CITY OF ATLANTA

EAST AREA WATER QUALITY CONTROL FACILITY IMPROVEMENTS

FC-4906A AND FC-7383A

Question from Brandon Dow Lakeshore Engineering *on Thursday, Jul 17, 2025 at 03:15 PM EDT*

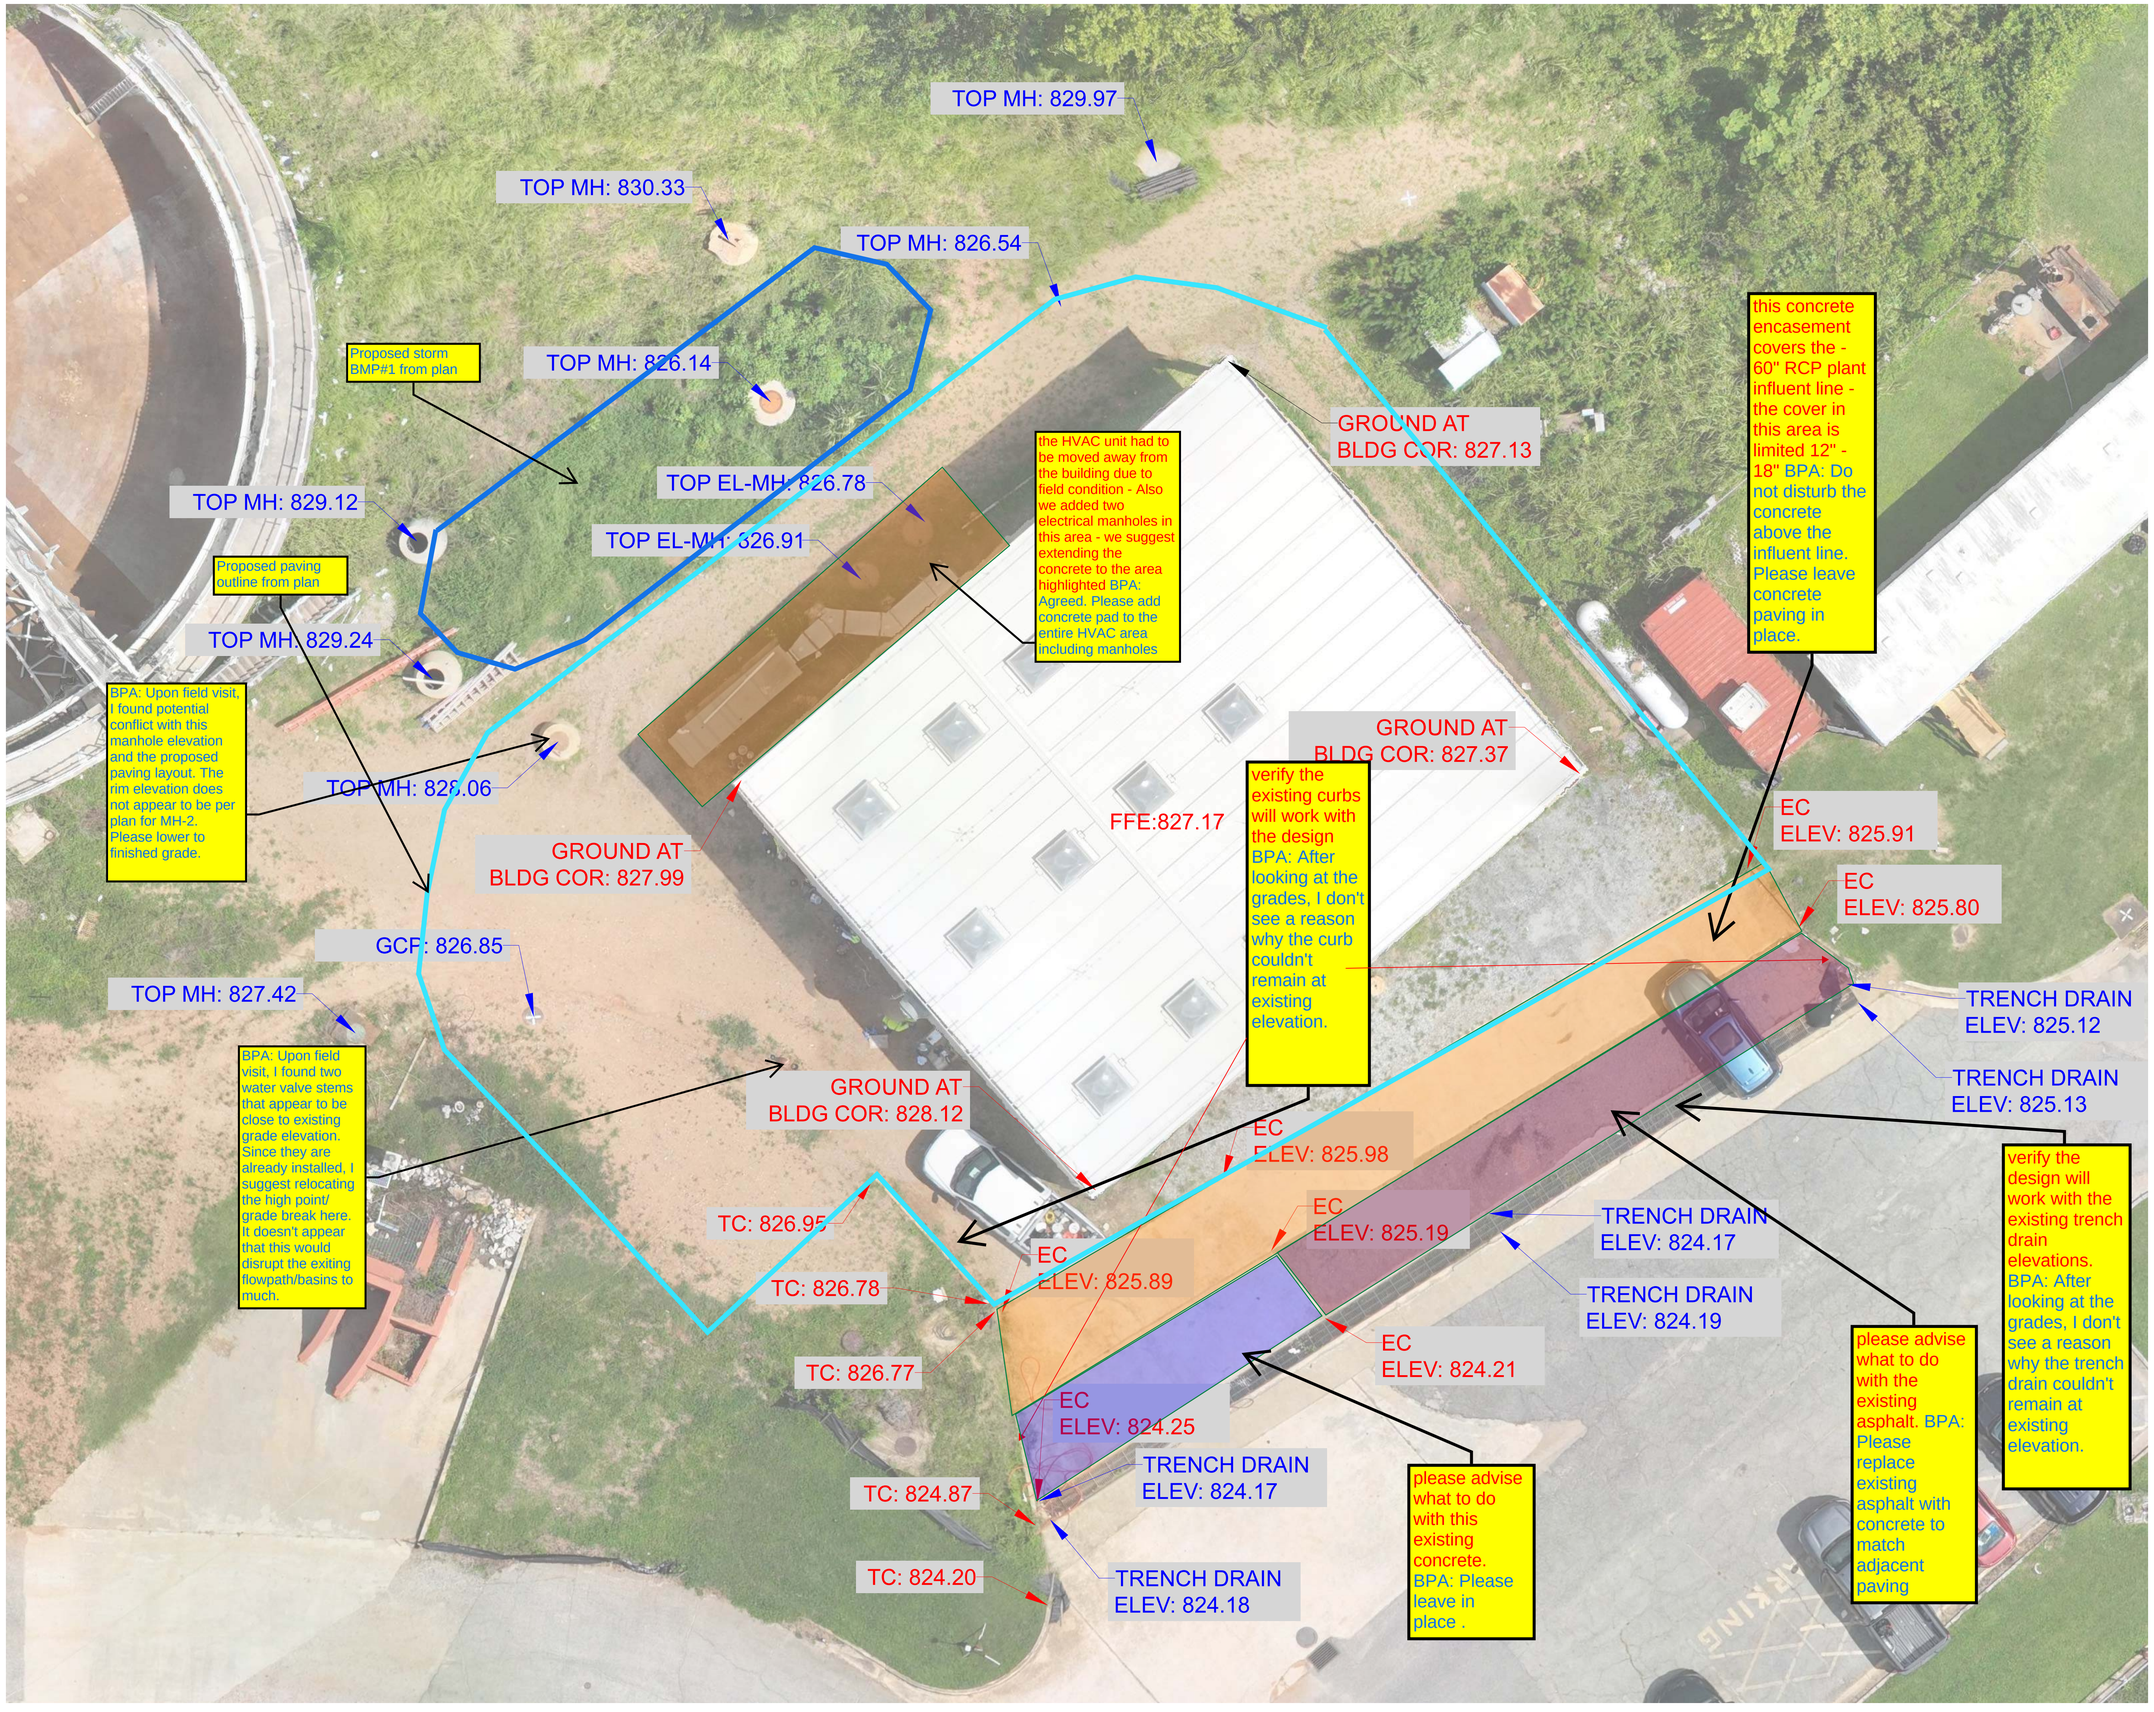
Various items around the sludge dewatering building have changed due to field conditions on the site. Attached is the as built elevations of the area. Please review and provide a final grading plan for the area.

See attached revised sheets C-008, C-009, C-010, C-011.
See attached new sheets RFI-01A and RFI-01B.

Question from Brandon Dow Lakeshore Engineering *on Tuesday, Jun 13, 2023 at 10:09 AM EDT*

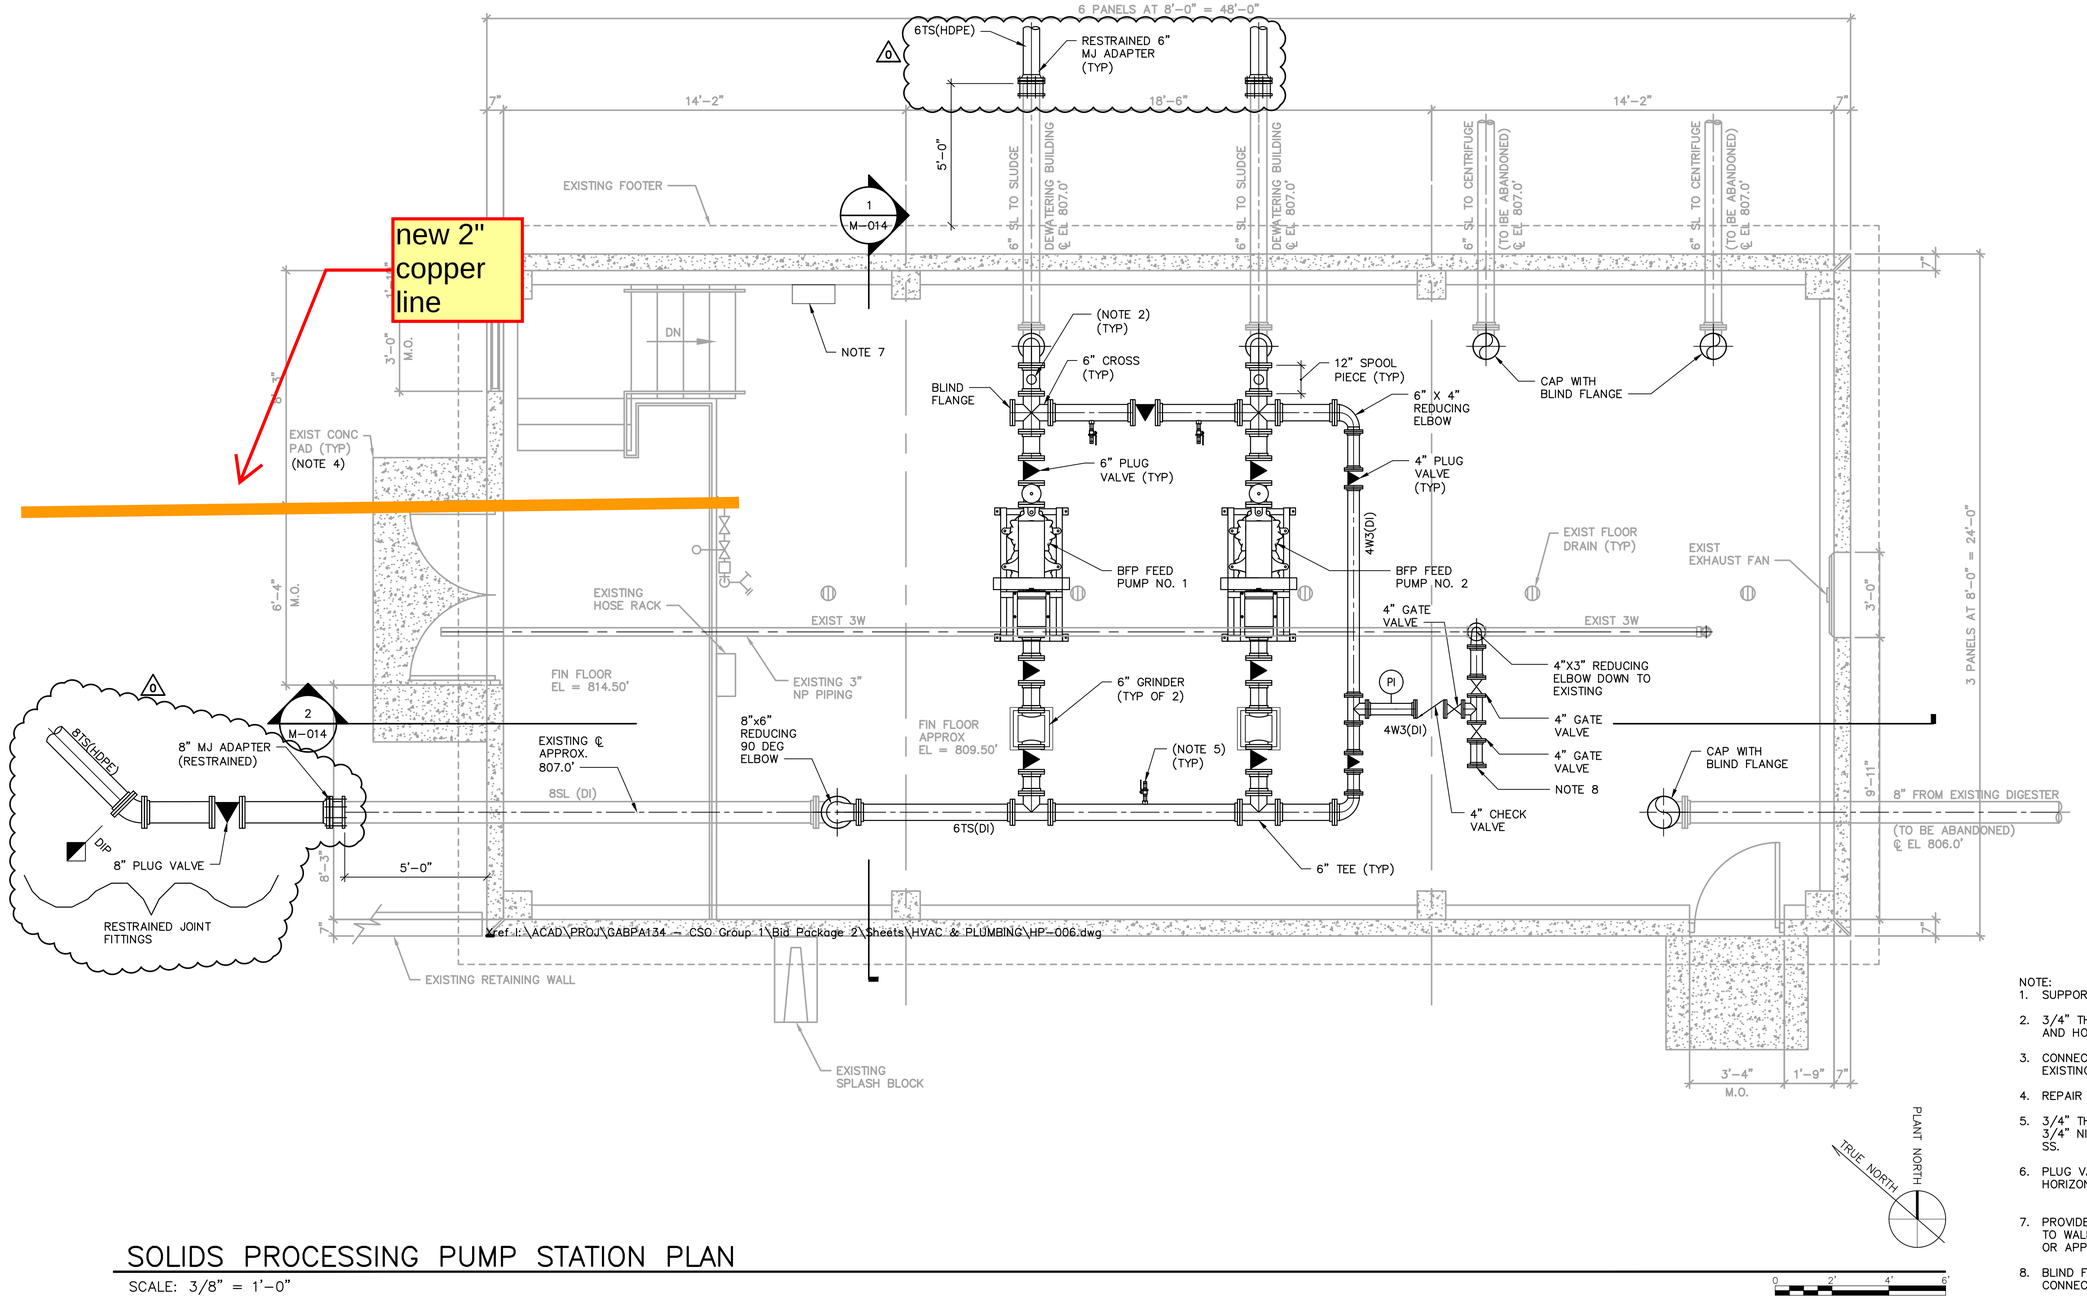
The existing water line feeding the solids proc. pump station had multiple holes in it. We propose installing a new 2" copper line from the existing valve into the building. The line can be up sized to 4" once exposed in the building.

Activity

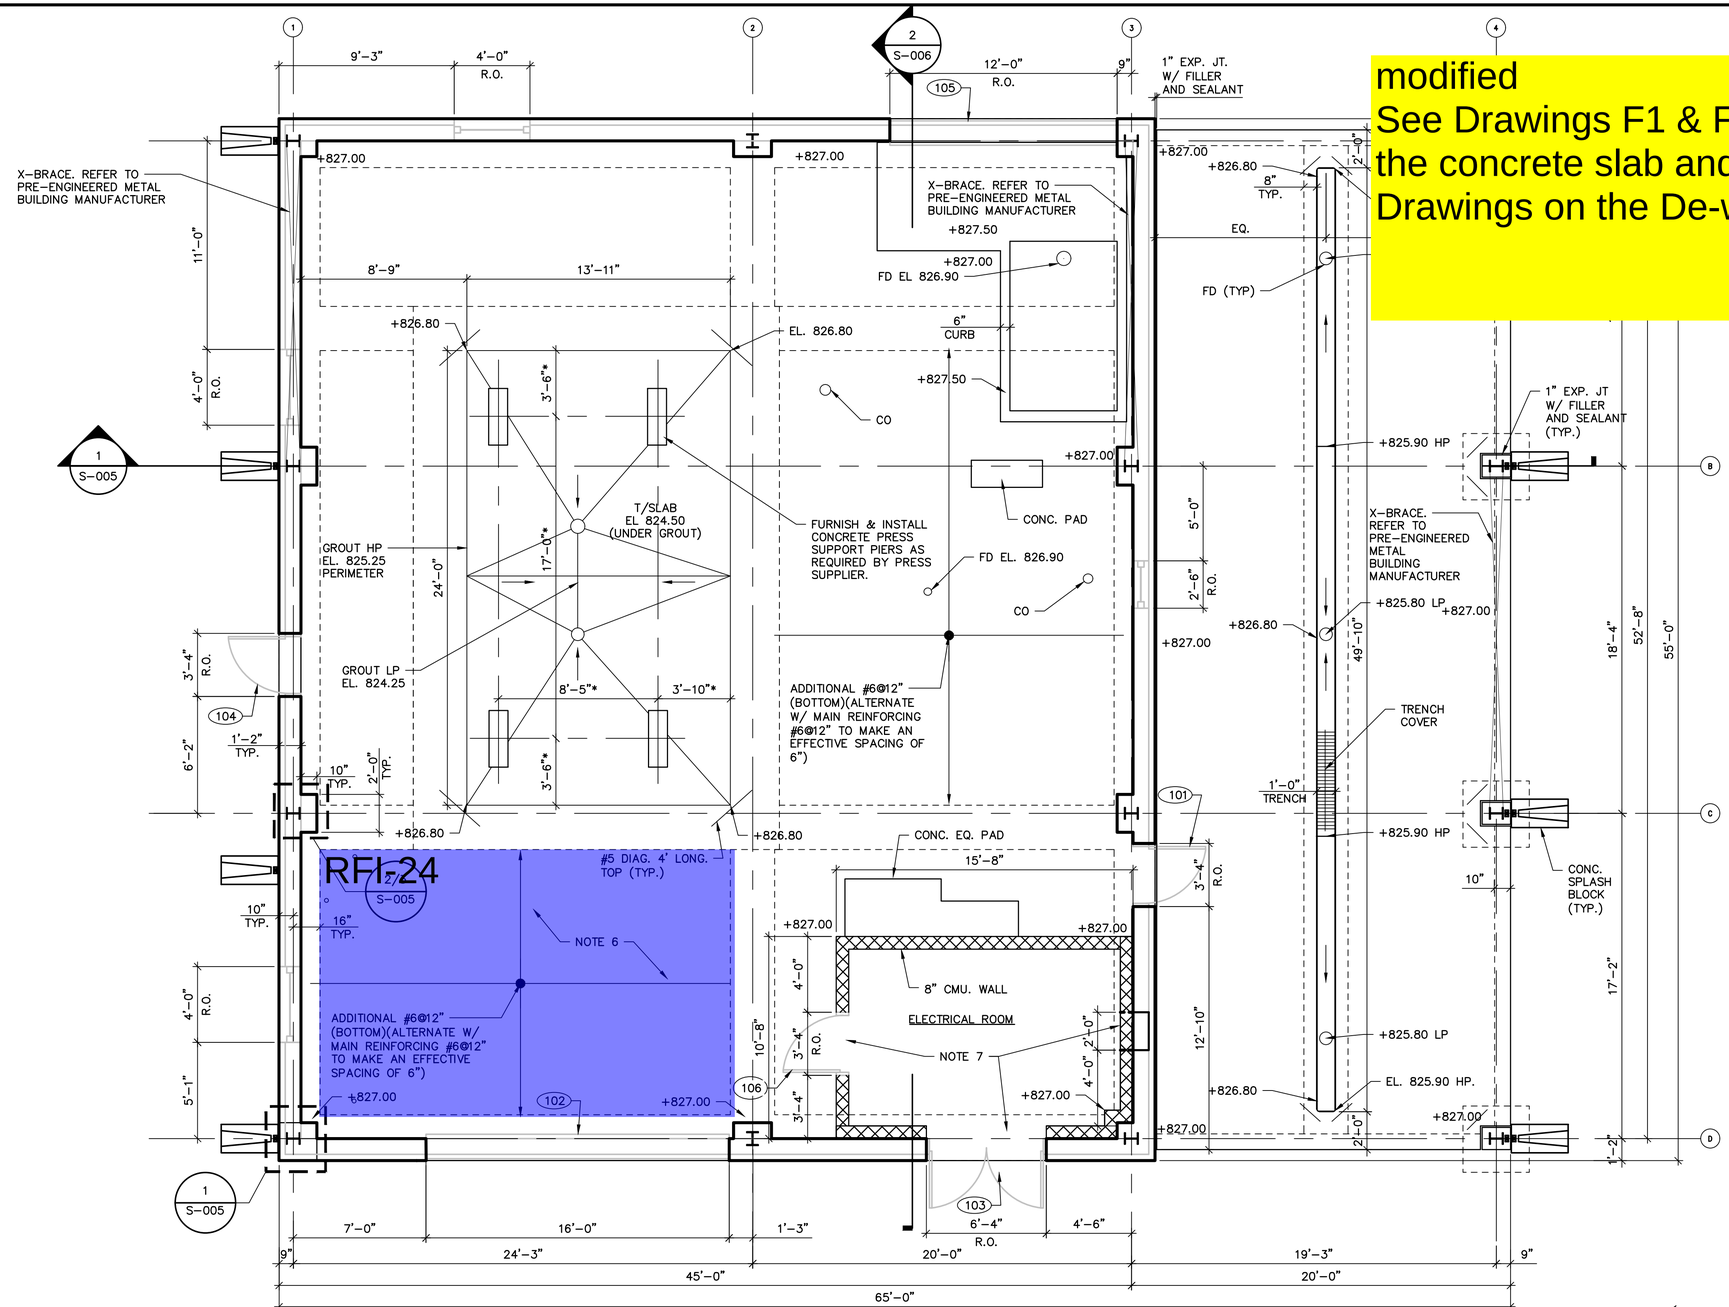
note 6 on drawing S-003 describes a floor coating that is typically used in areas that see high amounts of equipment scrapping. We feel the specified 4500 psi concrete will provide a long-lasting surface for the belt press and all other surfaces in this area. Lakeshore has included $25,071.00 in the bid for this work and can offer this amount to delete the product. If it is needed, please clarify where the intended area is. (we've highlighted the area we included). If needed, we could propose a standard spray on hardener as well. Deleting this product will also improve the project schedule. Please advise.
